# Access Compliance Report

## Public Rights-of-Way

### (Curb Ramps)

Intersection ID: 17502	Main Street: HEATHERDALE_CT	Cross Street: PINEY GROVE_RD	Location: NE
ADA ID: CB1E70322828	Ramp Type: BlendTrans1	Initial Pass/Fail: Fail	Overall Compliance: No
Severity Score: 10			
Codes/Mitigation Info/Possible Solution		Field Measurements/Component Compliance

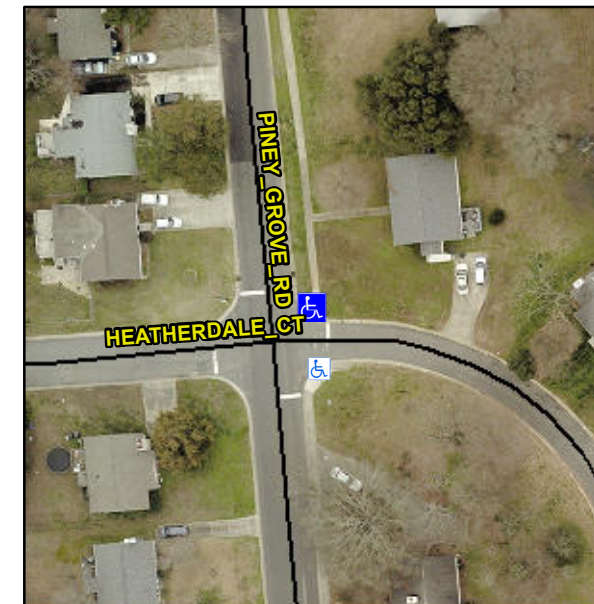
**Not Found, R304.5.1, R304.5.3**

Compliance	Description	Data	Compliance	Description	Data
N/A	Ramp Length (in)	56.0	Yes	BlendTrans Slope (%)	3.0
No	Ramp Width (in)	47.5	No	BlendTrans XSlope (%)	2.6
N/A	Flare Type LT	N/A	N/A	Flare Type RT	N/A
N/A	Flare Slope LT (%)	N/A	N/A	Flare Slope RT (%)	N/A
N/A	Flare Traversable LT?	N/A	N/A	Flare Traversable RT?	N/A
N/A	Landing Length (in)	N/A	N/A	DWS Provided?	N/A
N/A	Landing Width (in)	N/A	N/A	DWS Contrast?	N/A
N/A	Landing Slope (%)	N/A	N/A	DWS Length (in)	N/A
N/A	Landing X Slope (%)	N/A	N/A	DWS Full Width?	N/A
N/A	Landing Curb? (Y/N)	N/A	N/A	DWS Offset (in)	N/A
N/A	Shared Landing?	N/A			
N/A	Gutter Ponding?	N/A	N/A	Gutter Slope (%)	N/A
N/A	Gutter Lip Ht (in)	N/A	N/A	Gutter X Slope (%)	N/A
N/A	Painted X Walk1?	No	N/A	Painted X Walk2?	No
	X Walk 1 Direction	To W		X Walk 2 Direction	To S
	X Walk 1 Width (in)	N/A		X Walk 2 Width (in)	N/A
	X Walk 1 Slope (%)	3.0		X Walk 2 Slope (%)	0.7
	X Walk 1 X Slope (%)	2.1		X Walk 2 X Slope (%)	0.2

N/A	Ramp inside XWalk1?	N/A	N/A	Ramp inside XWalk2?	N/A
	Road Slope (%)	1.9		Clear Space?	N/A
	Road X Slope (%)	2.8	N/A	Clear Space to XWalk (in)	N/A
N/A	Any Obstructions?	N/A	N/A	Storm Grate/Utility Hazard?	N/A
	Obstruction Type			Storm Grate/Utility Type	
		N/A			N/A
			Yes	Surface Condition? (G/P)	Good
			No	Curb Slope (%)	7.6

**Remove & Replace Curb Ramp With Two New Directional Ramps or Equivalent.**
